UNITED STATES
NUCLEAR REGULATORY COMMISSION
WASHINGTON, D. C. 20540
November 28, 1984

Docket No. STN 50-470

SUBJECT: SUMMARY OF NOVEMBER 9, 1984 MEETING WITH COMBUSTION
ENGINEERING (CE) TO DISCUSS OPERABILITY OF SHUTDOWN
COOLING SYSTEM RELIEF VALVES OF SYSTEM 80 DESIGN

MATERIALS

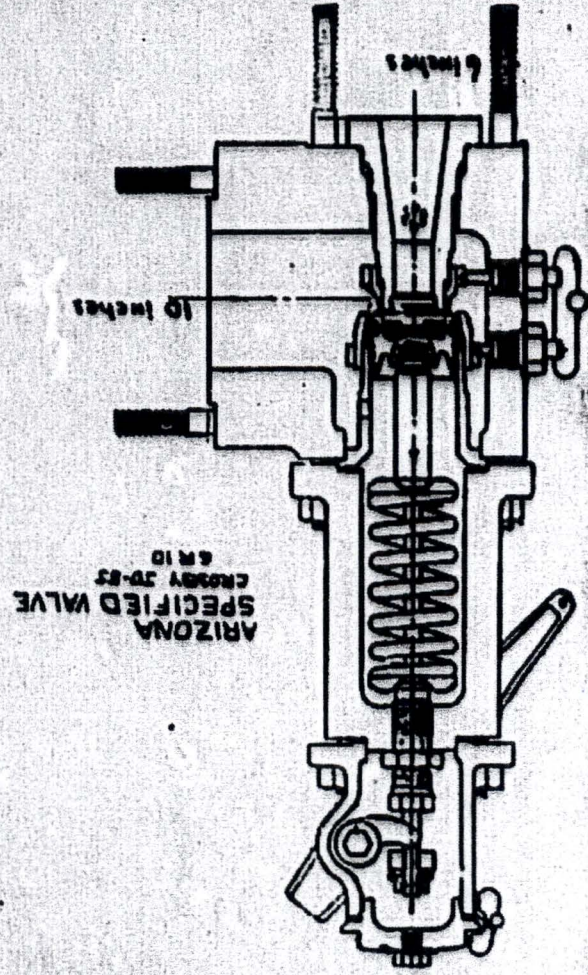
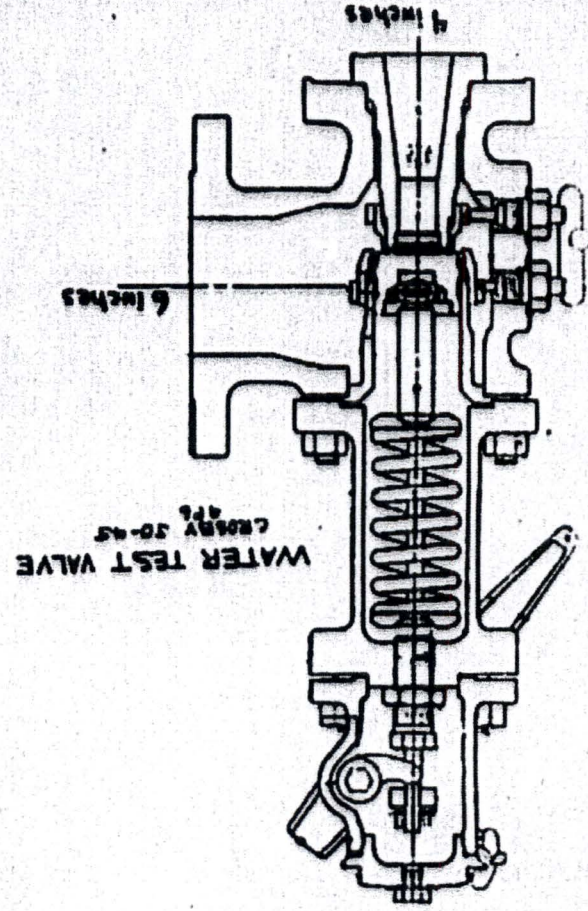
- SELECTED TO AVOID GALLING
- TESTED BY CROSBY FOR WATER SERVICE
- SEATING MATERIALS ARE THE SAME
- DISC MATERIALS ARE THE SAME (316 STAINLESS STEEL)
- 6R10 GUIDE ASTM A743 BETTER GALLING RESISTANCE
- 4P6 GUIDE 316 STAINLESS STEEL

RELATIVE RELIEF VALVE STABILITY VS. SET PRESSURE

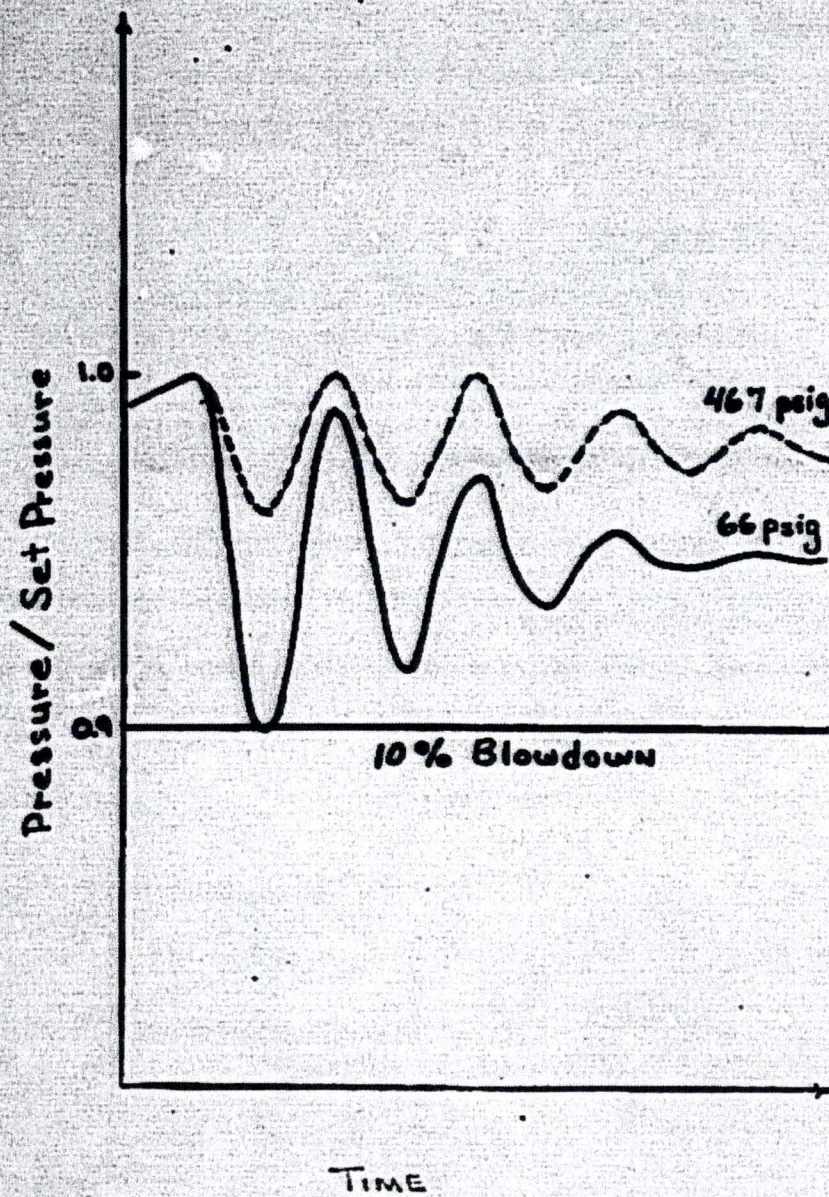
- VALVE/FLUID INTERACTION EXPECTED TO BE THE SAME
- RELIEF VALVE OPERATING CHARACTERISTICS EXPECTED TO BE THE SAME
- PERCENT BLOWDOWN SHOULD BE COMPARABLE
- MARGIN TO STABILITY INCREASES WITH INCREASING SET PRESSURE FOR CONSTANT PERCENT BLOWDOWN

VALVE IS MORE LIKELY TO CHATTER AT LOW PRESSURE IF PERCENT BLOWDOWN IS THE SAME.
